CITY OF KELOWNA
MEMORANDUM

APPLICATION NO.: Z05-0014 & OCP05-0003

LOCATION: 5241 Chute Lake Road

PURPOSE: To amend the Official Community Plan Future Land Use designation from Future Urban Reserve to Single/Two Unit Residential and Major Parks/Open Space and to rezone from the A1 – Agriculture 1 zone to the RU1h – Large Lot Housing (Hillside Area) & P3 – Parks and Open Space in order to facilitate a single dwelling housing subdivision of ~125.

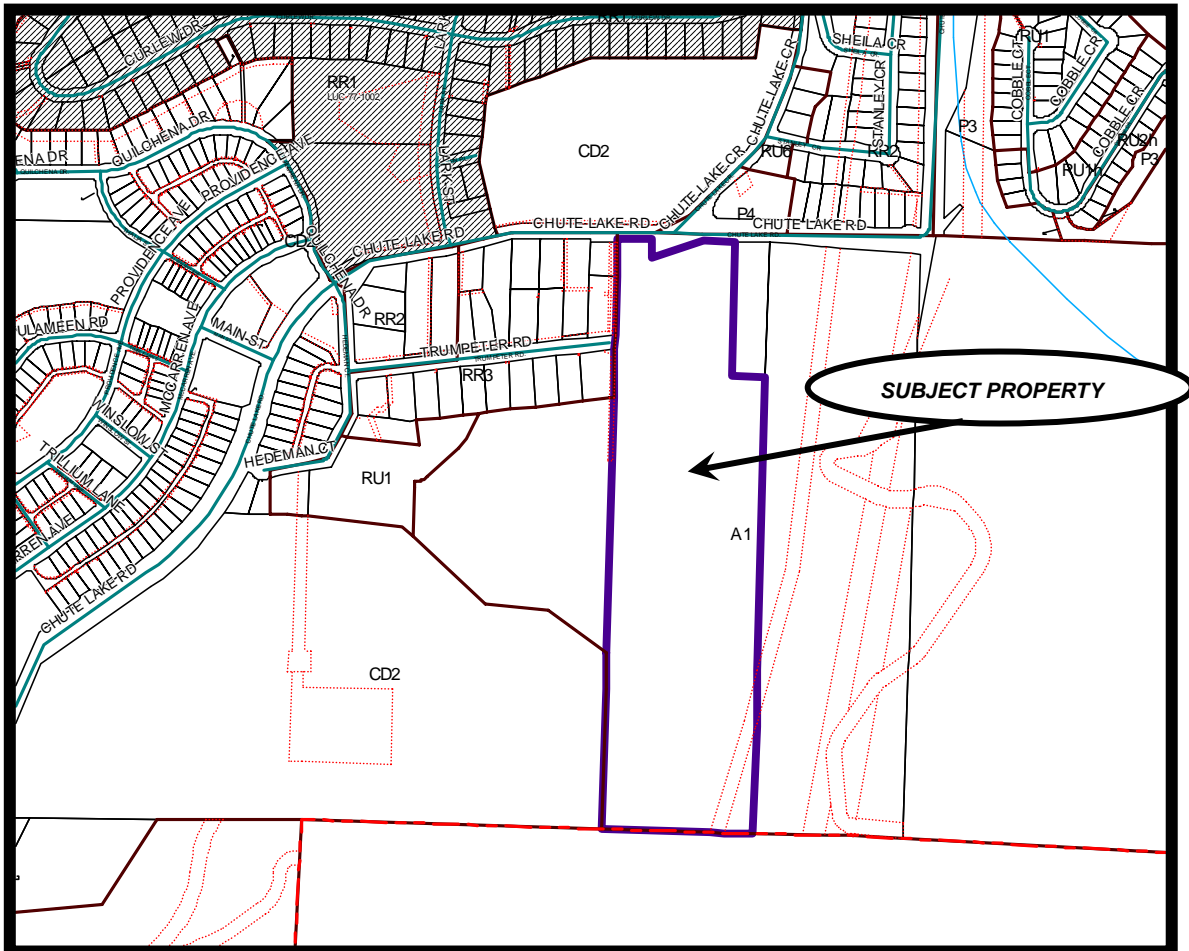
The preliminary plan of proposed subdivision provides the necessary road connectivity to the adjacent properties and also provides an open space corridor that will allow for a linear trail through the subject property and which will continue through the adjacent land to the east when it develops in the future. This Open Space Corridor will be zoned P3 – Parks and Open Space as part of the rezoning of this subject property.
